Access Compliance Report

Public Rights-of-Way

(Curb Ramps)

Intersection ID: 11882	Main Street: N_PINE_ST	Cross Street: W_5TH_ST	Location: W
ADA ID: BC4A6F5D7B84	Ramp Type: BlendTrans1	Initial Pass/Fail: Pass	Overall Compliance: No
Severity Score: 0.25			
Codes/Mitigation Info/Possible Solution		Field Measurements/Component Compliance

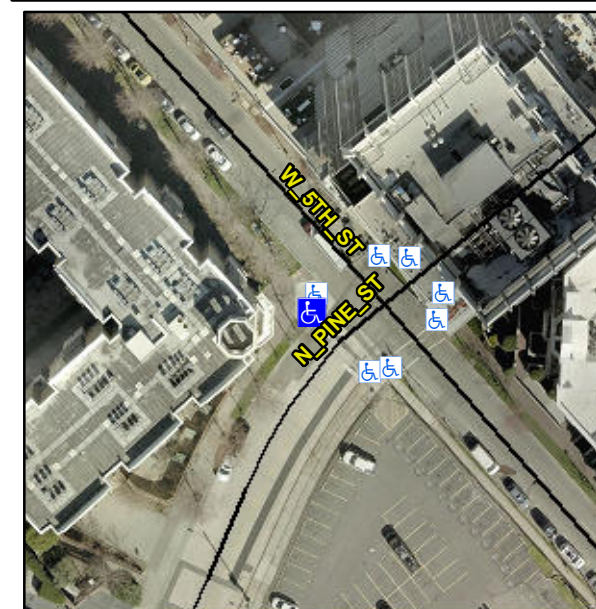
Not Found, R304.5.3, R305.2

Compliance	Description	Data	Compliance	Description	Data
N/A	Ramp Length (in)	123.0	Yes	BlendTrans Slope (%)	1.0
Yes	Ramp Width (in)	60.0	No	BlendTrans XSlope (%)	4.6
N/A	Flare Type LT	Sloped	N/A	Flare Type RT	Sloped
Yes	Flare Slope LT (%)	7.0	Yes	Flare Slope RT (%)	6.3
N/A	Flare Traversable LT?	Yes	N/A	Flare Traversable RT?	Yes
Yes	Landing Length (in)	60.0	Yes	DWS Provided?	Yes
Yes	Landing Width (in)	60.0	Yes	DWS Contrast?	Yes
Yes	Landing Slope (%)	0.3	Yes	DWS Length (in)	24.0
No	Landing X Slope (%)	3.6	Yes	DWS Full Width?	Yes
N/A	Landing Curb? (Y/N)	No	No	DWS Offset (in)	5.0
N/A	Shared Landing?	Yes			
Yes	Gutter Ponding?	No	Yes	Gutter Slope (%)	0.2
Yes	Gutter Lip Ht (in)	0.0	No	Gutter X Slope (%)	3.2
N/A	Painted X Walk1?	Yes	N/A	Painted X Walk2?	N/A
	X Walk 1 Direction	To SE		X Walk 2 Direction	N/A
	X Walk 1 Width (in)	100.0		X Walk 2 Width (in)	N/A
	X Walk 1 Slope (%)	1.3		X Walk 2 Slope (%)	N/A
	X Walk 1 X Slope (%)	4.2		X Walk 2 X Slope (%)	N/A

Yes	Ramp inside XWalk1?	Yes	N/A	Ramp inside XWalk2?	N/A
	Road Slope (%)	4.2		Clear Space?	Yes
	Road X Slope (%)	1.3	N/A	Clear Space to XWalk (in)	N/A
Yes	Any Obstructions?	No	Yes	Storm Grate/Utility Hazard?	No
	Obstruction Type			Storm Grate/Utility Type	
		N/A			N/A
			Yes	Surface Condition? (G/P)	Good
			No	Curb Slope (%)	9.5

Remove & Replace Curb Ramp With Two New Directional Ramps or Equivalent. Remove & Replace Gutter.
